Final Evaluation of the Acoustics of the APS Conference Center

ANL/MCS-TM-212

Technical Memorandum No. 212

November 1995

Figure 3.

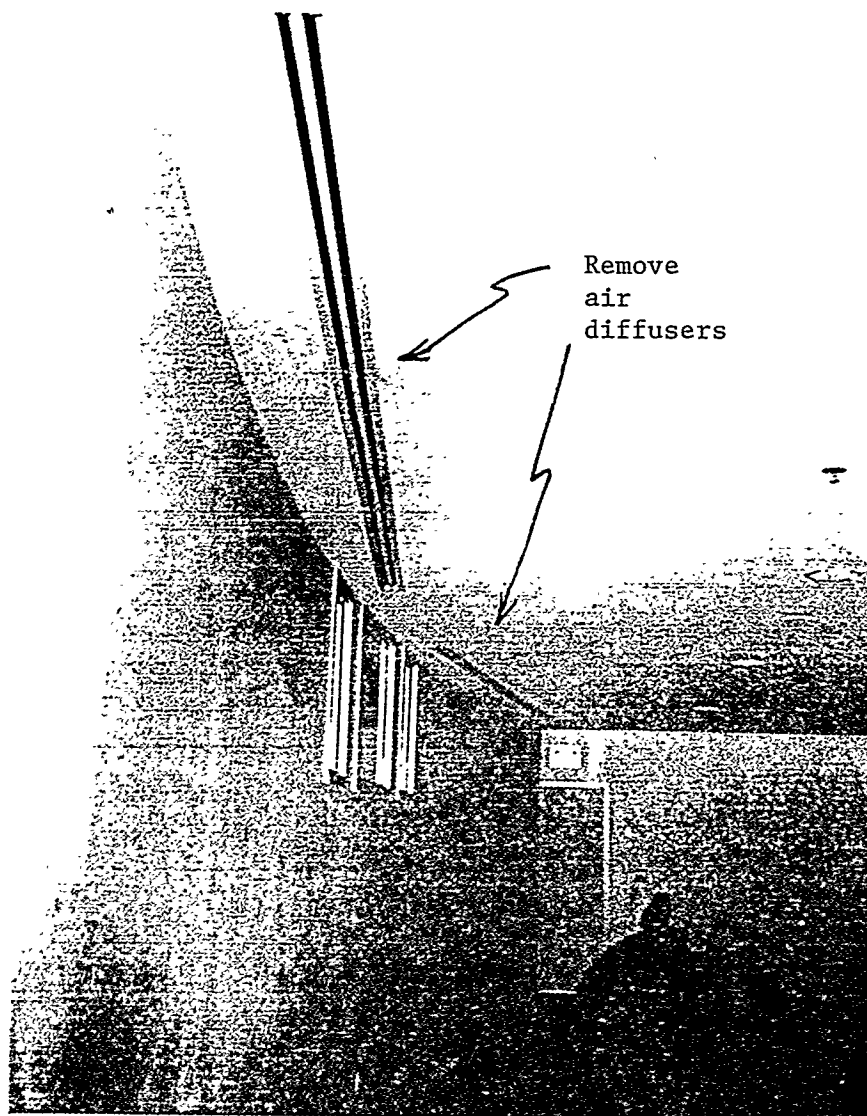
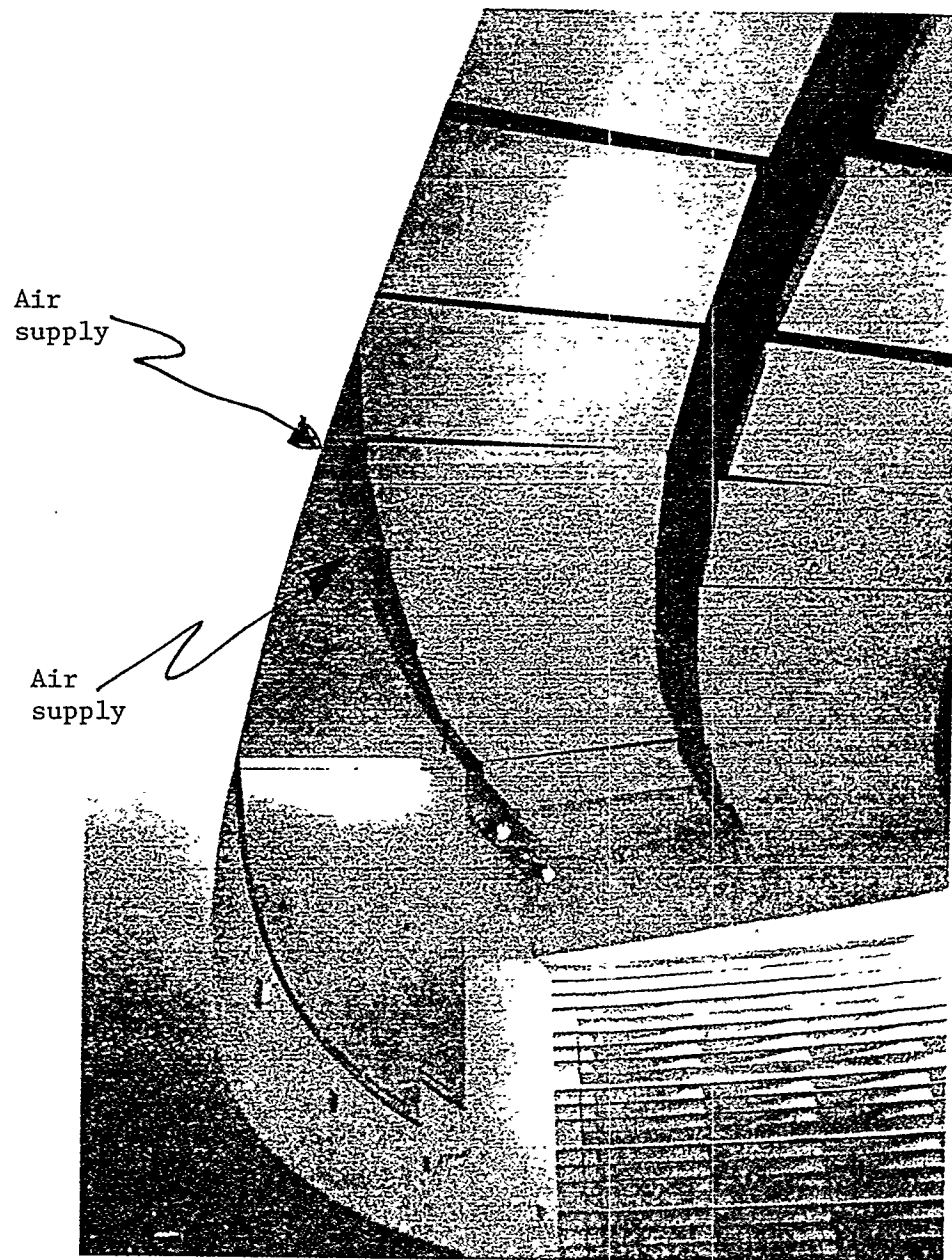
1. Air-Handling System: Noise is primarily turbulence-induced by diffusers and is affected by high-velocity flow and improper placement of air supply locations.

Solution: Reduce flow speed. Remove the internal dampers on all the ducts. Remove diffusers from site in Figure 3. Expand (by a factor of 2 or 3) the air supply ducts in Figure 4 and remove the diffuser grills. Seal every other air supply in Figure 5, and remove diffuser grills of ducts that are not sealed. It would be even better if all air supply ducts in Figure 5 were sealed. This judgment needs to be made based on comfort, but I think it would work if the air supply ducts in Figure 4 are enlarged considerably. The proscenium wall should be removed; see Figure 6a. However, if this proscenium wall is not removed, the air supply ducts should be moved as high as possible from the floor and the diffuser grill removed; see Figure 6b.

Figure 6a. Remove proscenium walls

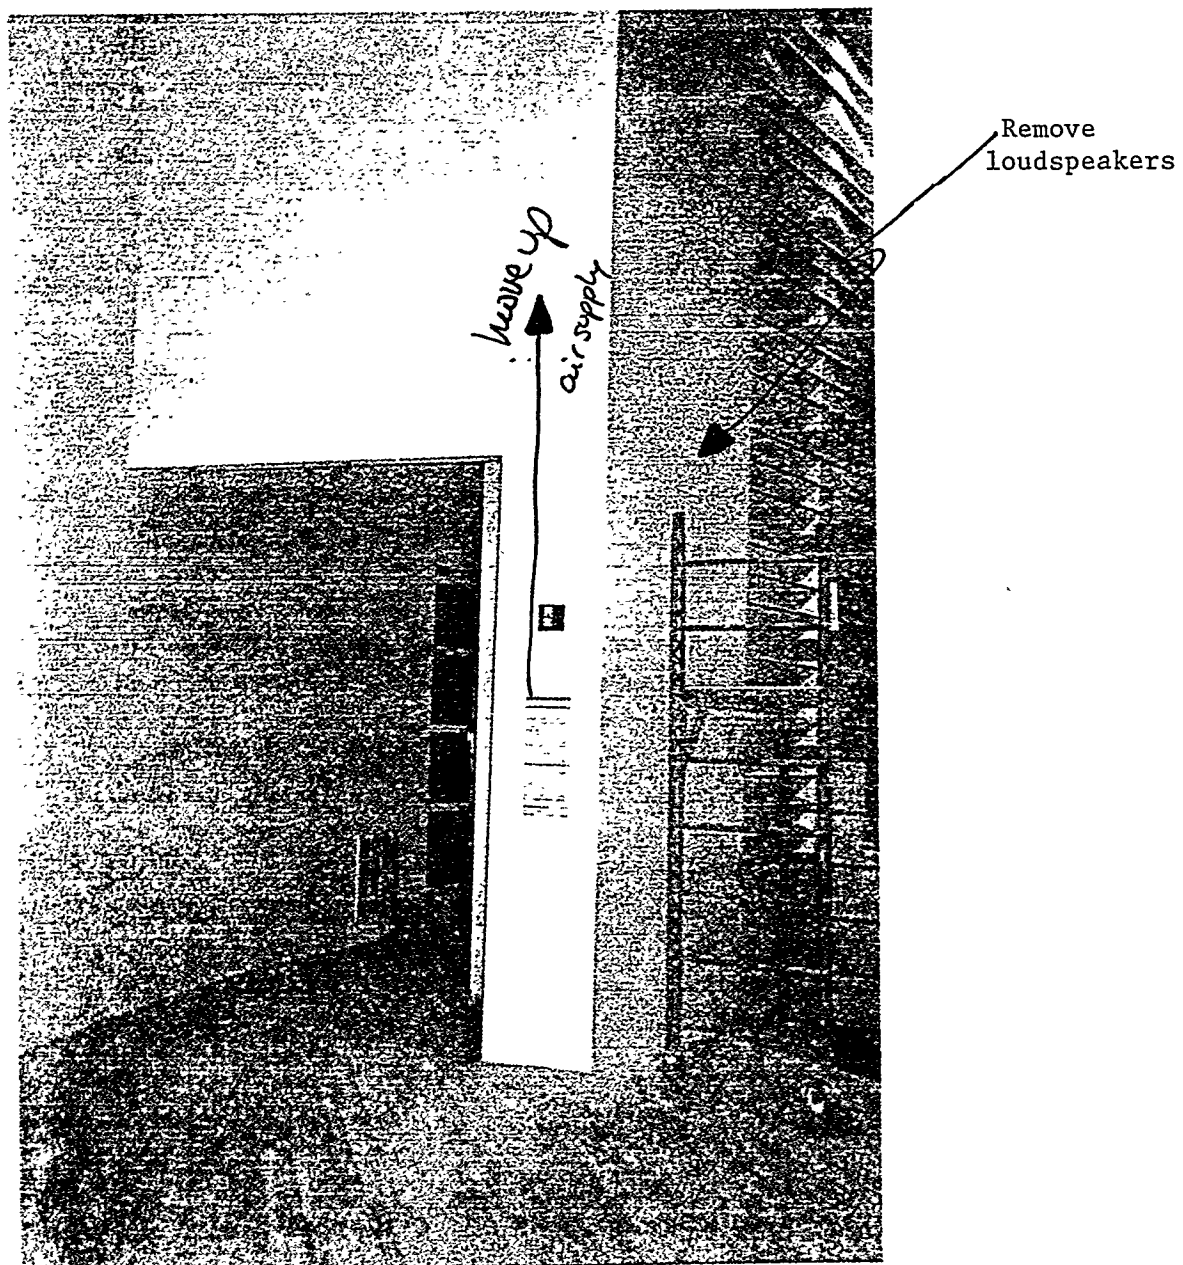
1. **Proscenium Frame Walls (Figure 6):** Decouples stage acoustically from the rest of the hall. There is an extremely annoying flutter echo between inside walls and the back wall of the stage. Walls take up useful stage space. It reinforces the negative qualities of an elliptical auditorium.

Solution: Remove altogether. If this is not possible, it is suggested that the inside walls be coated with acoustic tiles or Novowall. This ia a poor compromise, since it will reduce the amount of energy delivered to the hall.
